RE: Homestake Mining Company of California
– License SUA-1471
Grants Reclamation Project
Responses to NRC Request for Additional Information (RAI) dated 6/13/07

HOMESTAKE MINING COMPANY RESPONSES TO
Request for Additional Information, Homestake Mining Company,
Grants Reclamation Project
From the Nuclear Regulatory Commission

**SUBJECT: RESPONSE TO NRC REQUEST FOR ADDITIONAL
INFORMATION, COMMENT #2 REGARDING EMBANKMENT SLOPE
STABILITY OF EP3 EMBANKMENT**

Homestake Evaporation Pond Number 3: Response to NRC Request for Additional Information Comment No. 2

Figure 1. General EP3 Soil Profile for SLIDE Analysis

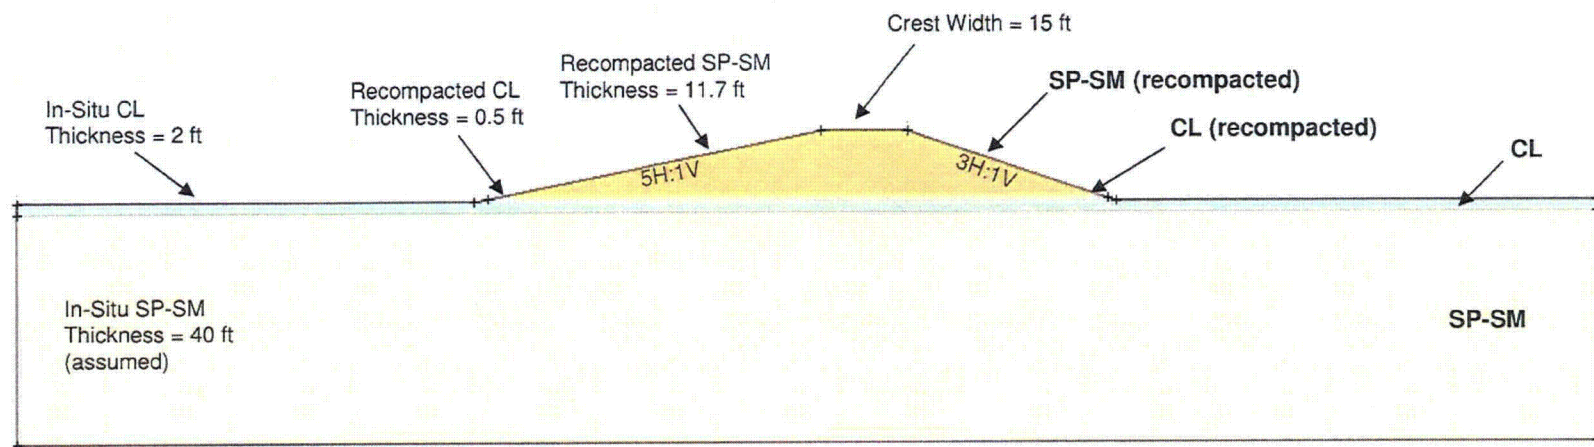
Provide an appropriate slope stability analysis for the perimeter embankment.

A slope stability analysis was performed on the southern-most corner of EP3. Results are shown on Figures 1 through 17, Attachment A. This location was chosen because it represents the area with the greatest amount of fill material and the corresponding largest embankment height of 12.2 feet. The in-situ soil thickness was determined from test pits SW-3 and SW-4 soil logs included in Attachment B of this response. These test pits are located near the southern corner of EP3; the test pit location map (Figure 17) is also reproduced in Attachment B. These logs show a surface lean clay (CL) layer thickness of 2 feet underlain by a poorly graded sand with silt (SP-SM) material.

The pond embankment will be composed of recompacted lean clay (CL) and poorly graded sand with silt (SP-SM) material. It is likely that the lean clay will be placed in a lift below the SP-SM soil as shown in Figure 1 located in Attachment A of this response. The thickness of the recompacted materials was determined from the embankment design section.

Figure 5. Static Analysis: Phreatic Surface 1, Simplified Bishop Method

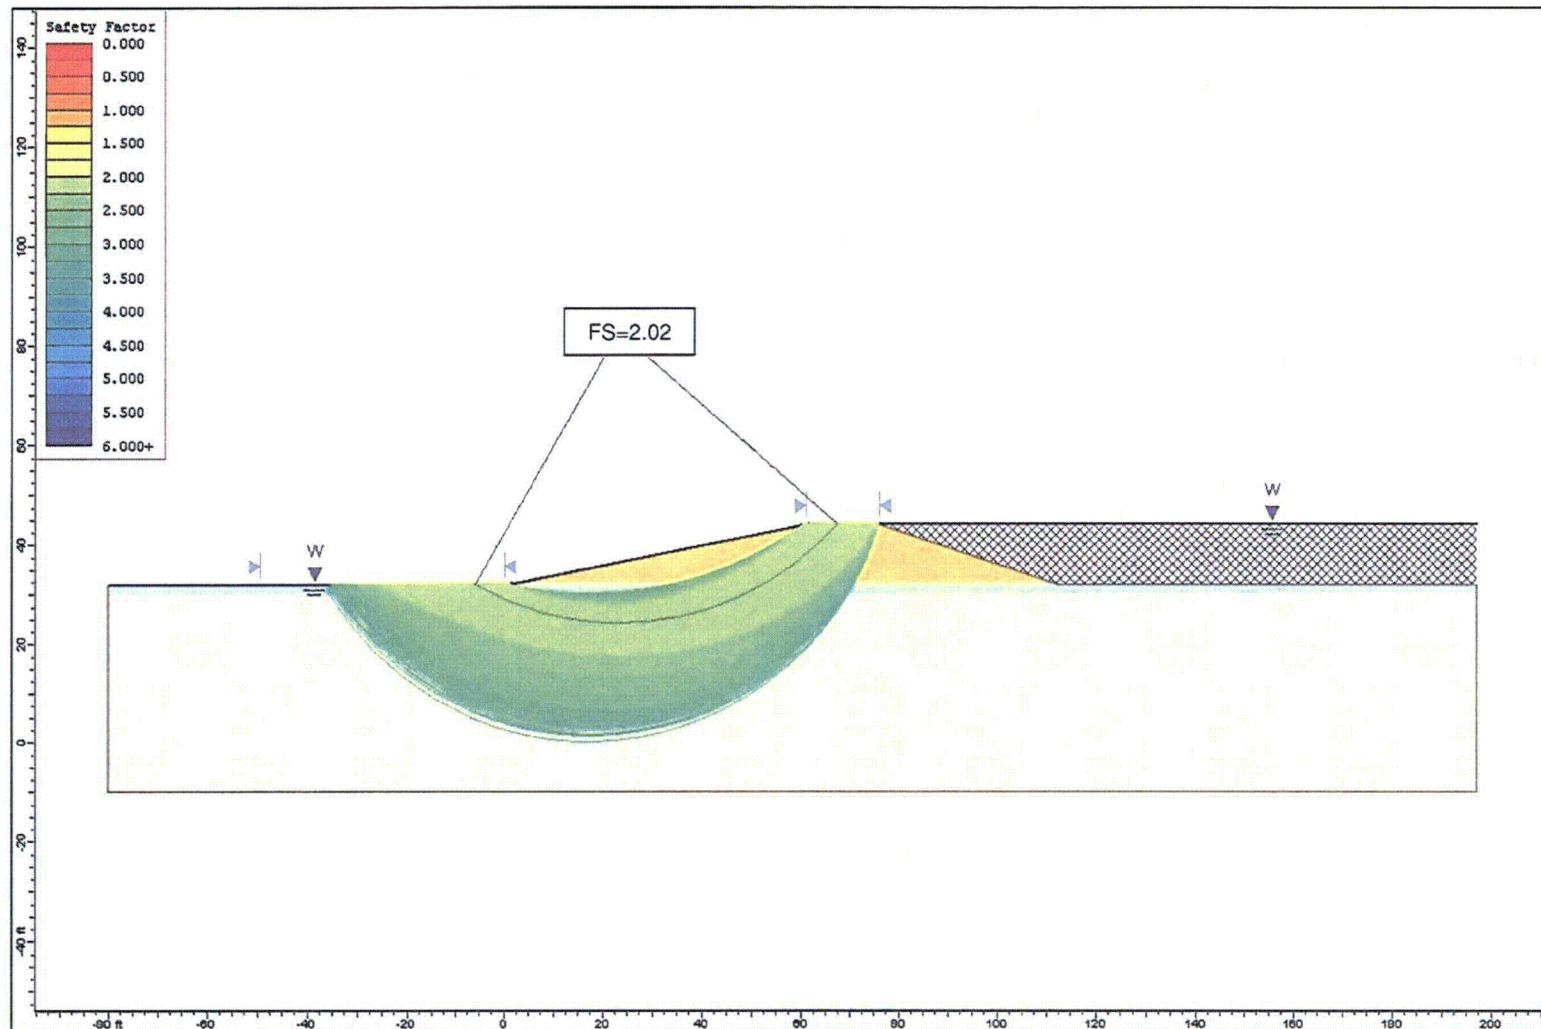
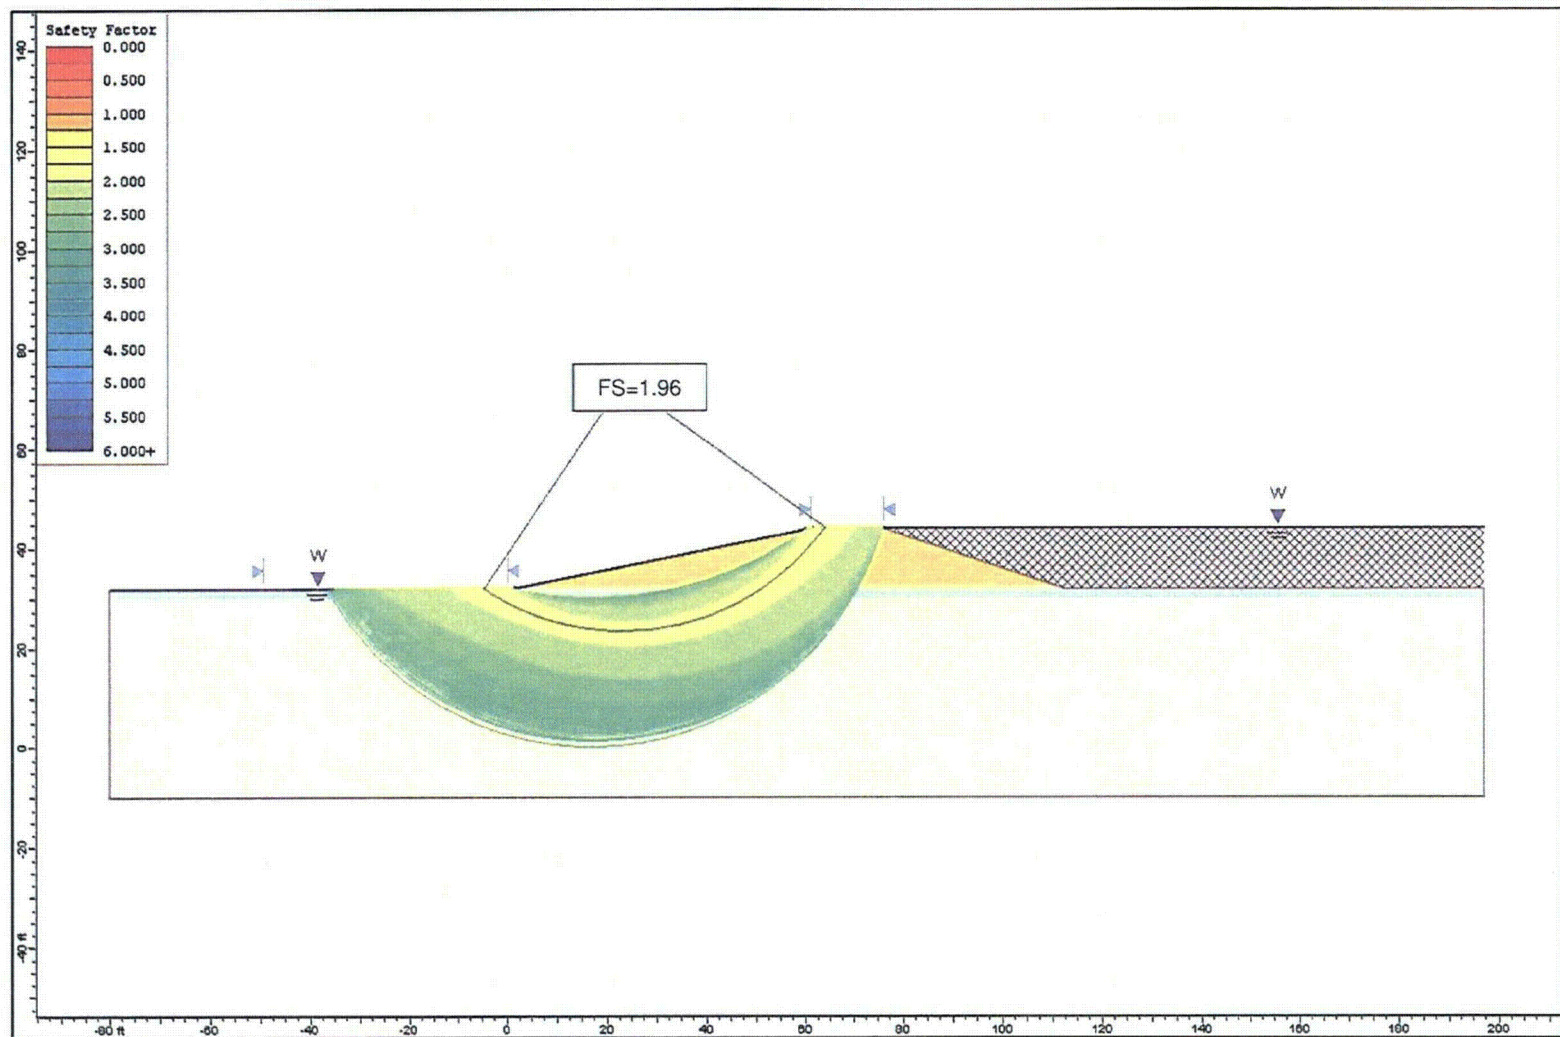
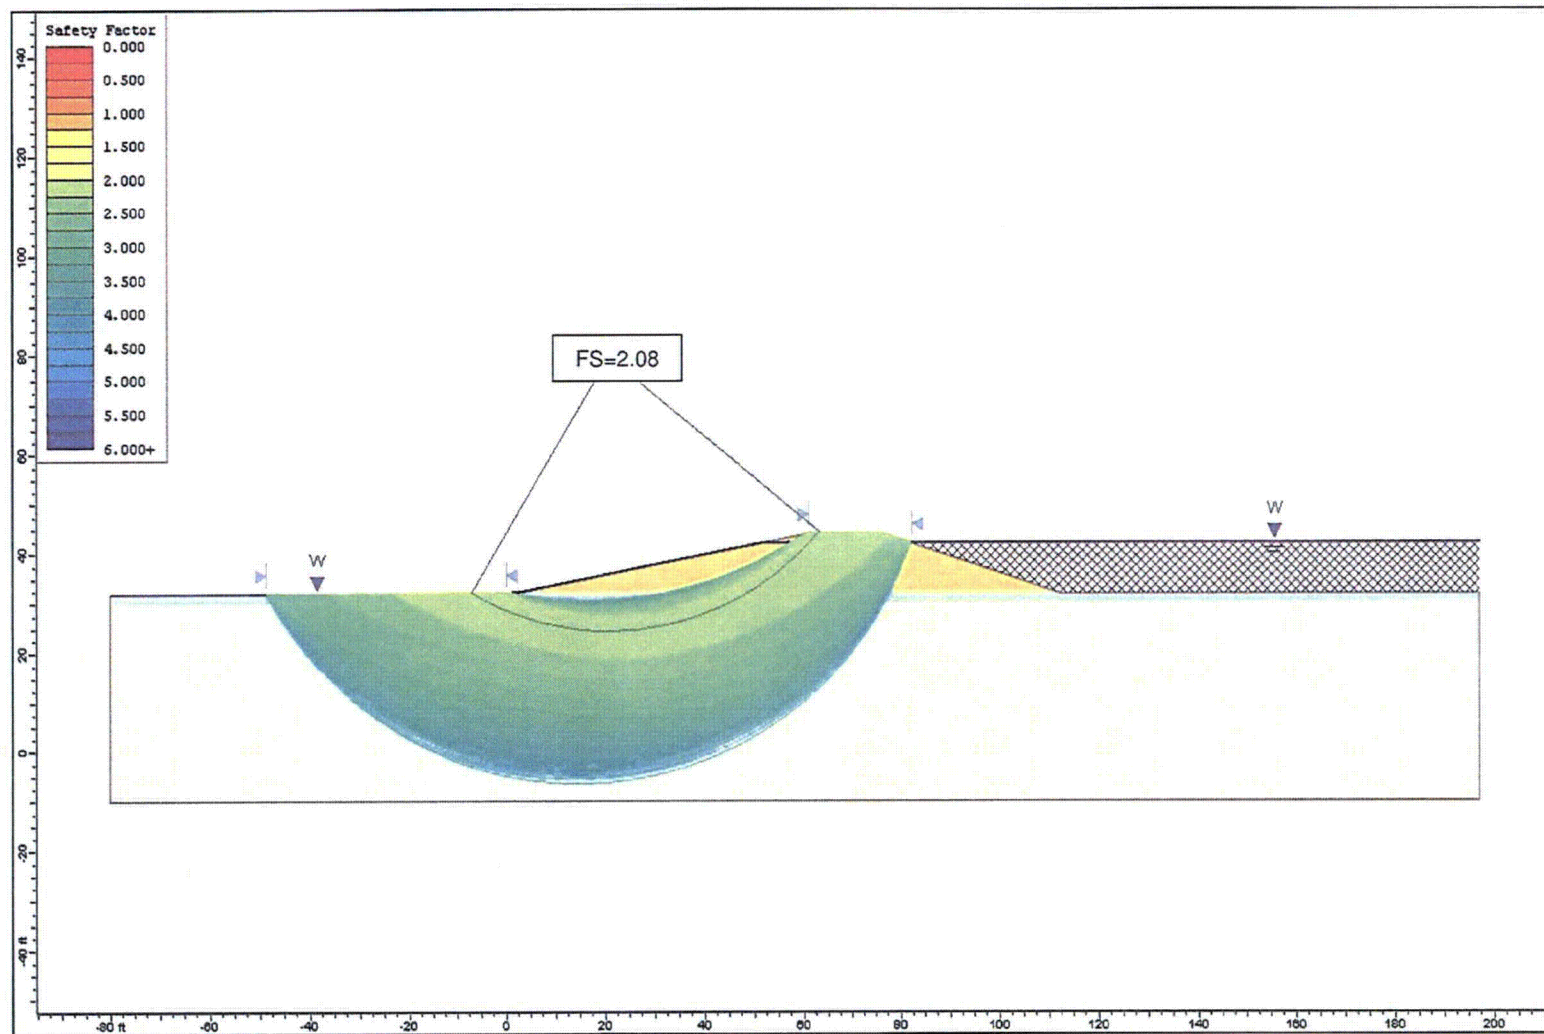
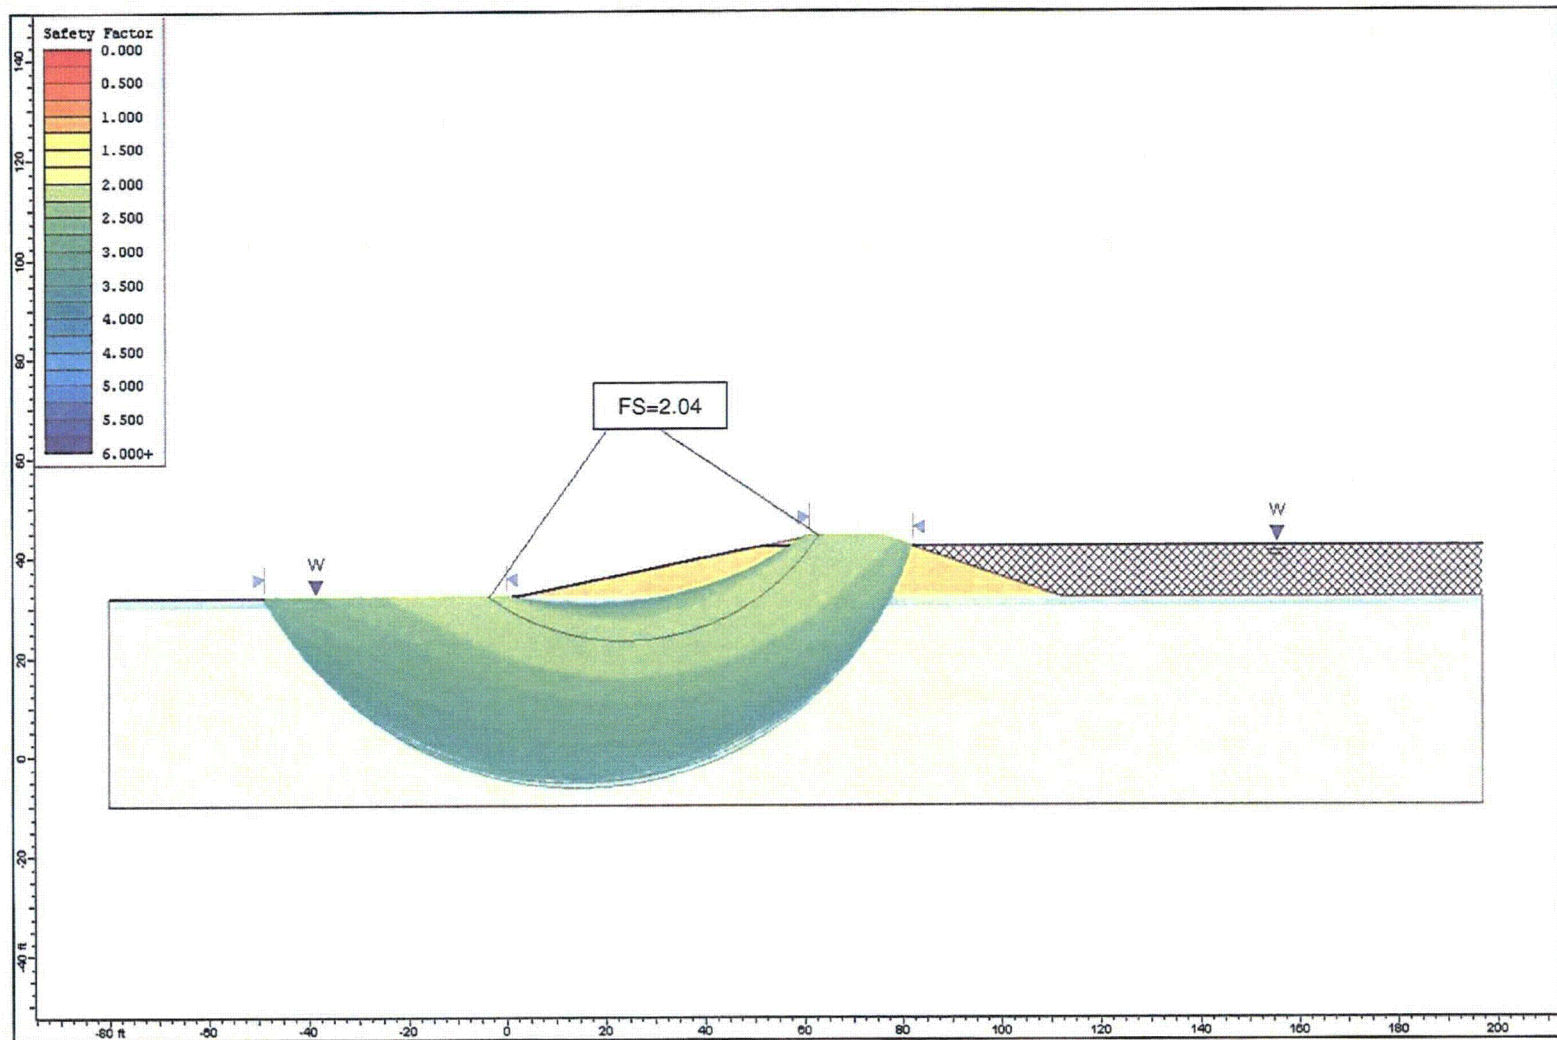
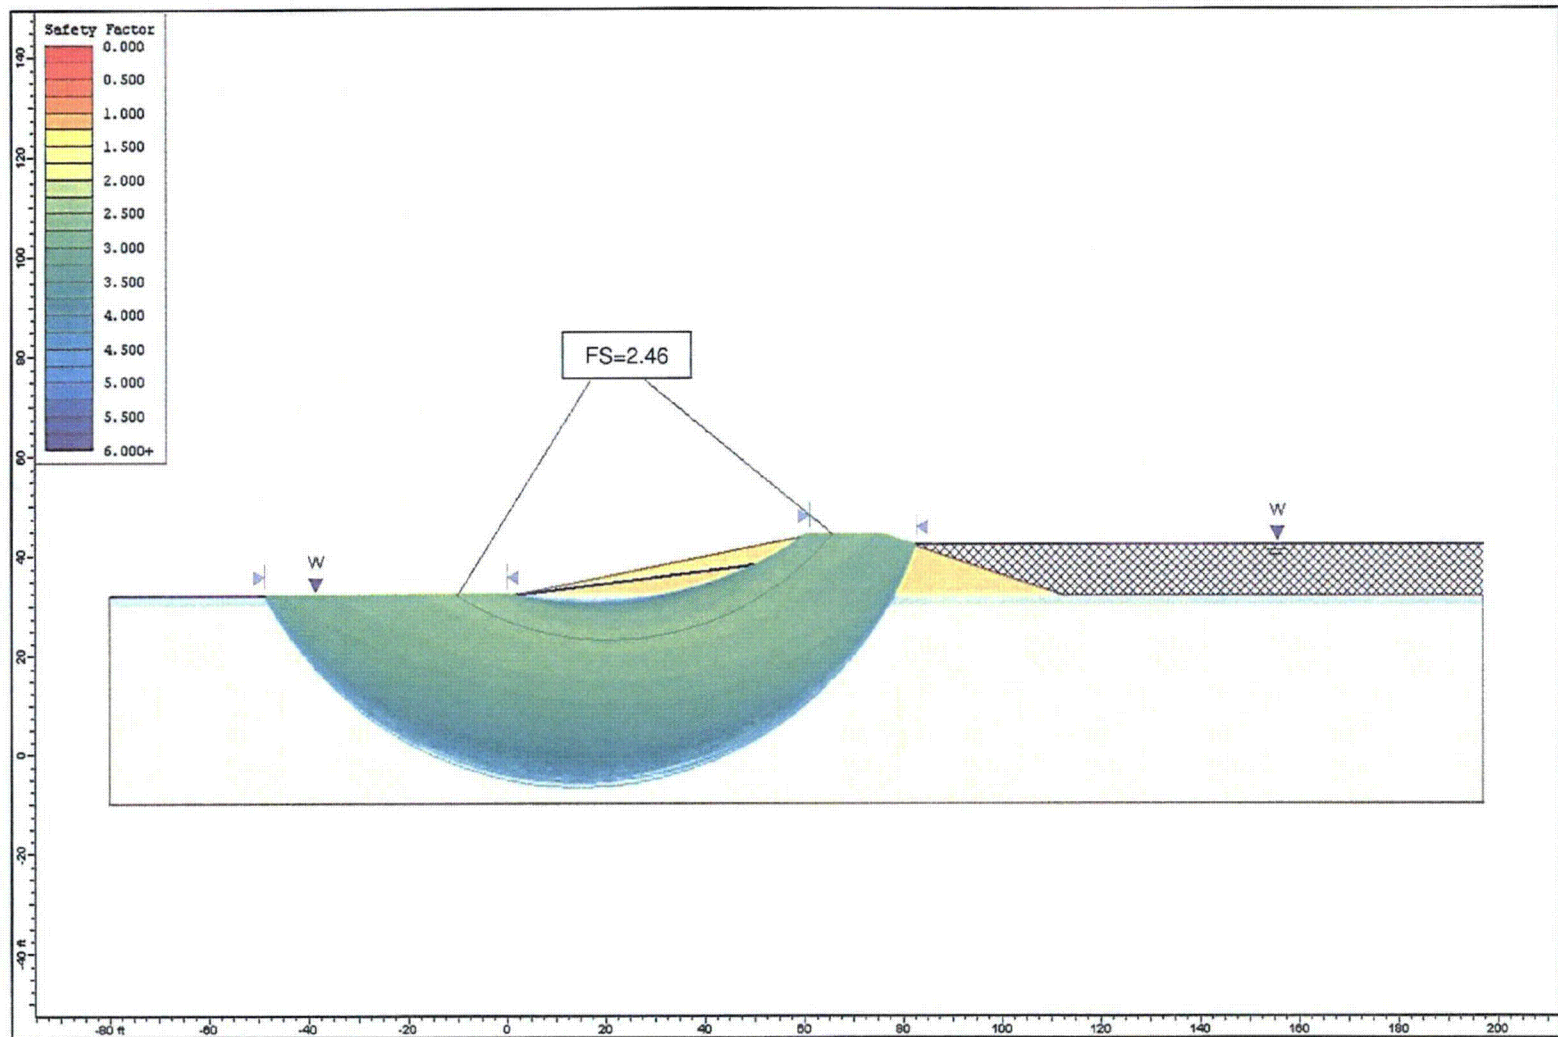
Discussion: A stability analysis should be prepared for the perimeter embankment for the critical cross section. The critical cross-section is likely to be where the embankment fill placed is the greatest. However, HMC will need to provide a basis for selection of whatever critical cross-section it analyzes. The stability analysis also should include a pseudo-static analysis to account for seismic loading. In addition, discuss why liquefaction is not a concern for this design.

completely saturated embankment. The second phreatic surface represents a water level equal to the maximum allowable water height, namely, a freeboard of 2 feet with saturation extending to the slope. The third scenario also represents a freeboard height of 2 feet but has the phreatic surface extending to the outslope toe. A minimum factor of safety for each scenario was determined using SLIDE. Results of the static slope stability analysis are presented in Table 2 and Figures 5 through 10 and figure 17.

Phreatic Surface	Minimum Factor of Safety Simplified Bishop Method	Minimum Factor of Safety Corrected Janbu Method
1	2.02	1.96
2	2.08	2.04
3	2.46	2.40
1 (fully saturated, no cohesion)	1.42	1.41
